**BEFORE THE PUBLIC UTILITY
COMMISSION OF OREGON**

LC 81

2023 Natural Gas Integrated Resource Plan.

OPENING COMMENTS OF THE
ALLIANCE OF WESTERN
ENERGY CONSUMERS

Figure 3

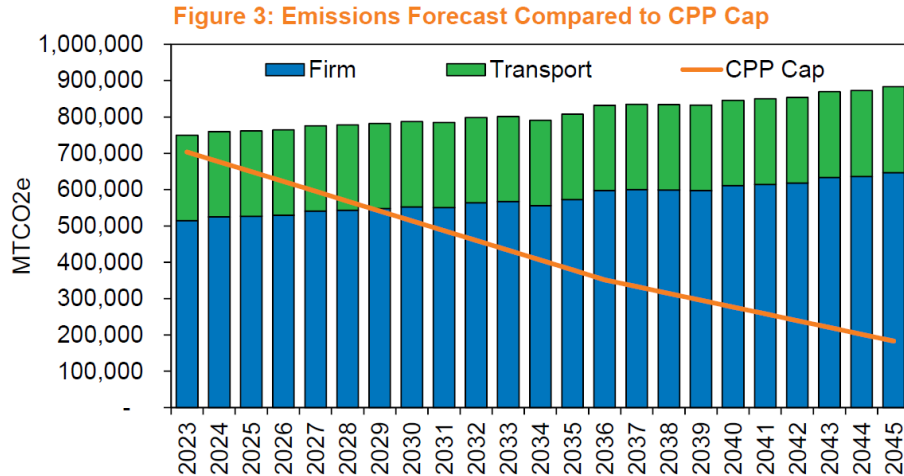
While AWEC is concerned with the cost impacts of these compliance pathways, AWEC does not necessarily oppose these three items as the primary means for complying with the CPP’s declining cap. There are limited options available today for complying with the CPP. Considering the rapid reductions to the CPP cap, and the technologies currently available, CCIs, Energy Efficiency, and RNG are currently the primary options for CPP compliance. In the long term, however, even implementing all of these options and other technologies may not be sufficient to meet the CPP cap. Figure 3 from the IRP, for example, details the enormous task involved in addressing the CPP cap, which is reproduced below.

Avista indicates that the first compliance periods will be satisfied primarily through a combination of CCIs and RNG procurement. However, the maximum amount of CCIs that can be purchased is capped and there is a technical limit to the savings achievable through energy efficiency. Therefore, RNG has been established as the primary method to comply with the CPP in the near term. In the 2023 IRP, Avista forecasts that it will acquire 864,000 dth of RNG in 2023 and 2.2 million dth of RNG in 2024. As a practical matter, however, AWEC is concerned that there is not sufficient time, or feed stocks available for Avista to acquire such significant amounts of RNG for the first compliance period, especially since NW Natural and Cascade are presumably competing for the same resources.

Further, as the CPP cap declines, there will be increased demand for RNG to meet regional utilities' demand. For purposes of meeting these requirements, the 2023 IRP forecasts the emergence of new technologies, including synthetic methane and hydrogen production, that will be necessary to meet the declining cost caps. Carbon capture is another technology that has significant potential.

While AWEC believes that there is promise in many low carbon fuel technologies and carbon capture, relying on the rapid development of cost effective technologies to meet the CPP caps calls into question whether the caps, themselves, will be attainable if the technology does not develop at the pace that Avista forecasts. Avista should provide more details surrounding its plan to comply with the CPP today if technology does not evolve as quickly as Avista assumes in the IRP.
